Service Bulletin

Bulletin No.: PIT4898C

Subject: The Drivers Power Seat Inoperative or SIR Light Is On With DTCs B0014 B0015 B0021

Models: 2010 Chevrolet Equinox

2321545

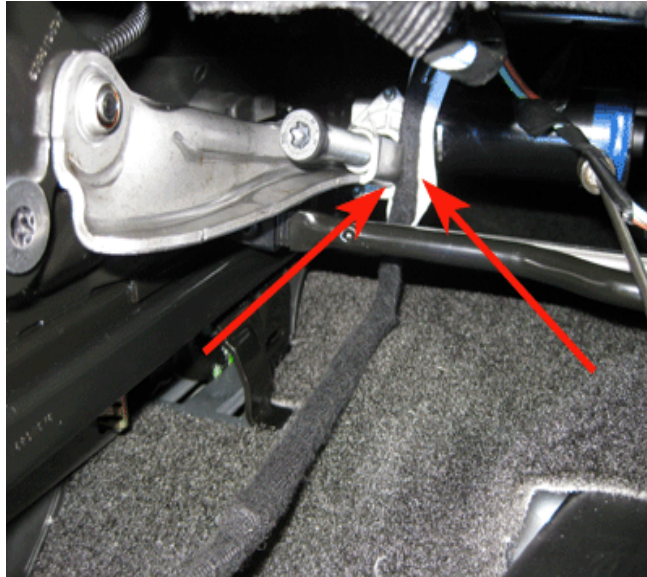
In rare cases, customers may complain that the driver's power seat is inoperative and/or the SIR light is coming on intermittently. When diagnosing the vehicle, DTC's B0014 and/or B0015 may be found in the SDM. The "PWR SEAT LT" fuse may be open in the underhood fuse block. This may be caused by a wire harness getting pinched under the driver's seat, between the seat frame and the power seat motor (see picture above). This concern happens when the seat is moved to the up position. This is applicable for both 4 and 8 way power seats.

2462212

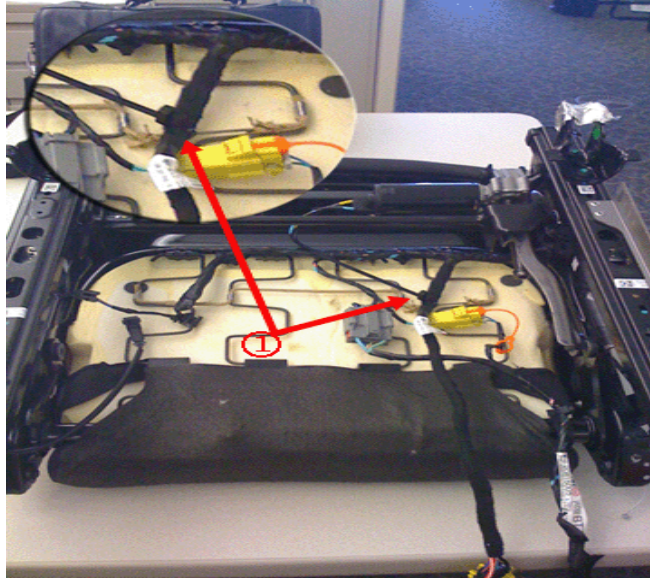
Check the wire harness under the seat for contact between the seat frame and the power seat motor. Picture shown is viewing the driver's seat from underneath (passenger's seat similar). If any wires are found to be damaged, repair them as necessary. For repair information regarding X308 and X310 see the latest version of 14710: Special Coverage Adjustment - Illumination of Airbag Readiness Light/Service Airbag Message

2526551

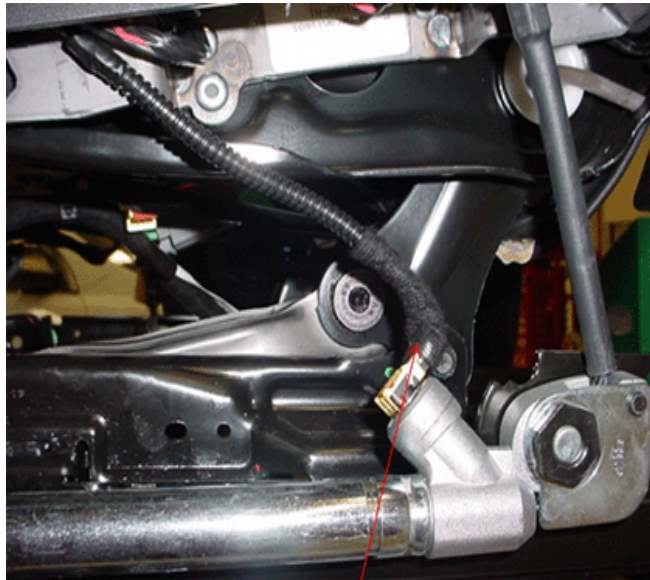
On vehicles equipped with 4 way seats, driver's side seat wiring to switch can become pinched and/or chafe on side shield bracket. This can add more pressure from the harness to the seat switch and damage the seat switch. This condition occurs when the seat is in the full down position.

Add abrasion tape and/or wiring conduit to harness in this area. Additionally, file burr smooth.
